# URBAN DESIGN COMMITTEE

2. Terminal Parking Design: Discussion on the potential options for parking design and Downtown Design Standards waivers at [139 S 10<sup>th</sup> Street](#).
3. [West Haymarket Streetscape Improvement completion](#): Canopy street, south of O Street- Advisory review.

**UDR23110 - Terminal Parking Design (139 S 10th Street)**

# ATTACHMENT C - Option 1 (with screening)

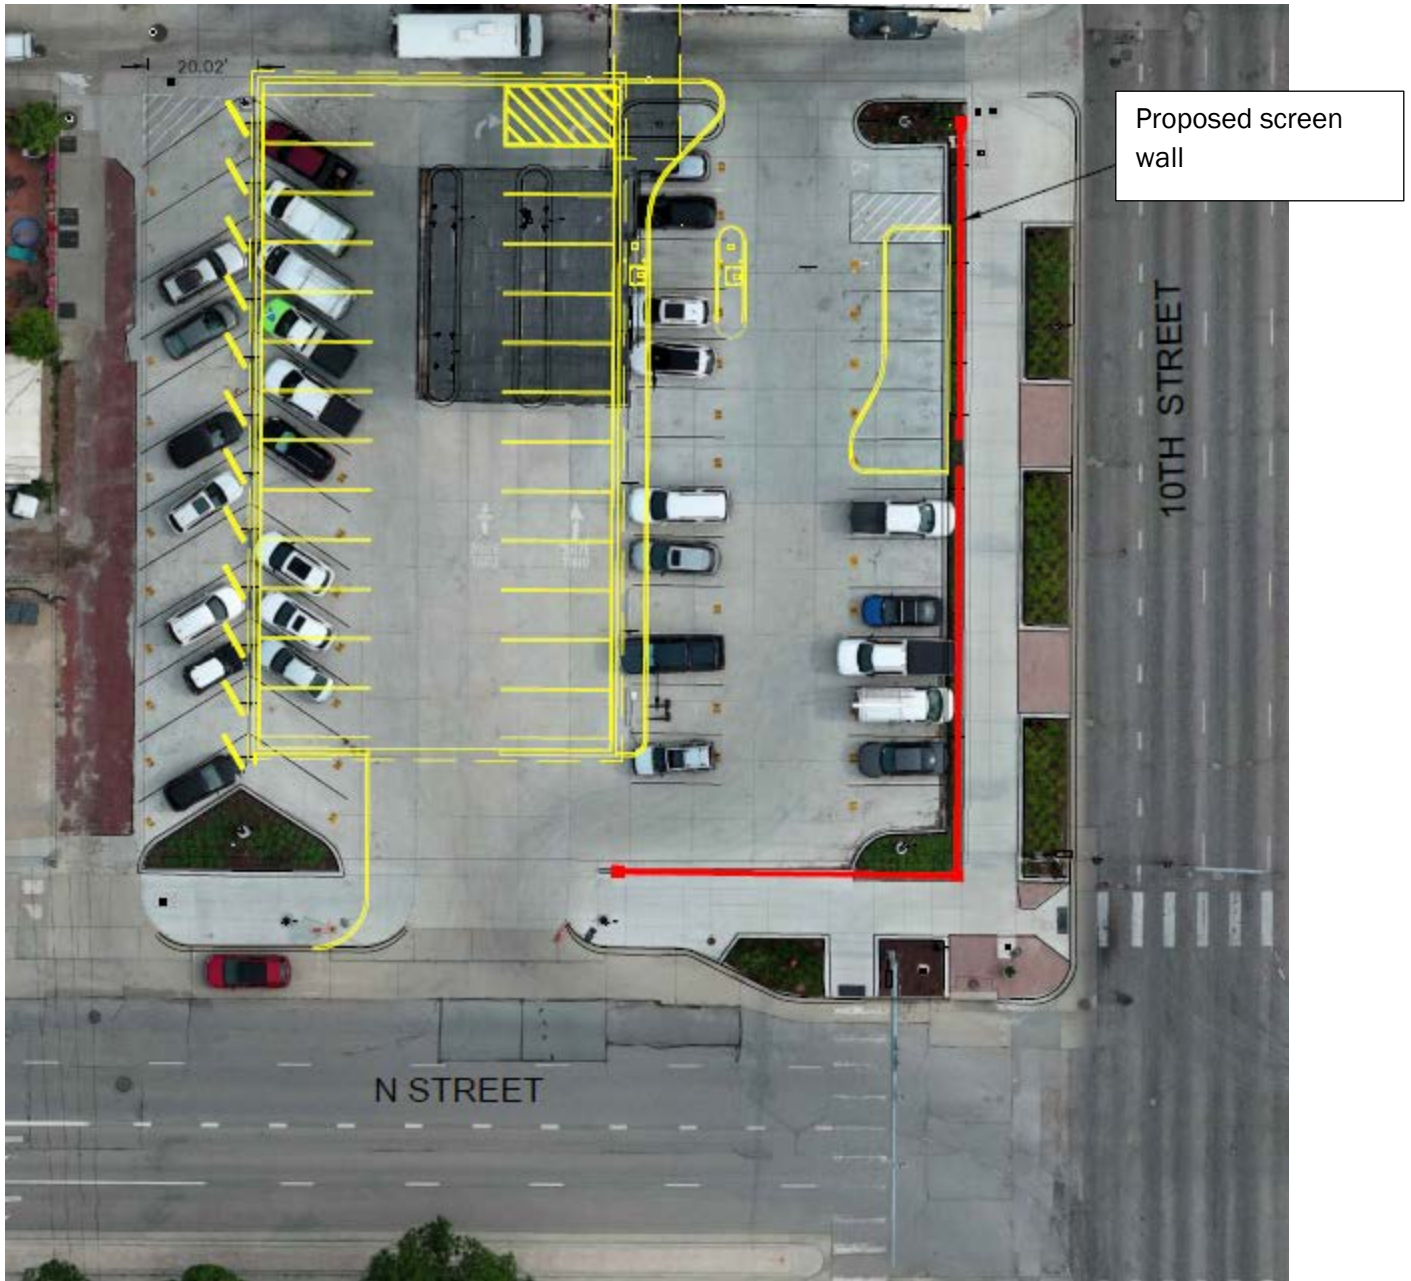
**Screen Location, Coverage, and Layout** (7.13 Screening for Downtown Lincoln) - *Further detail is needed to see if this proposal meets parking lot screening requirements. Option 1 shows a masonry wall along 10<sup>th</sup> street and part of N street*
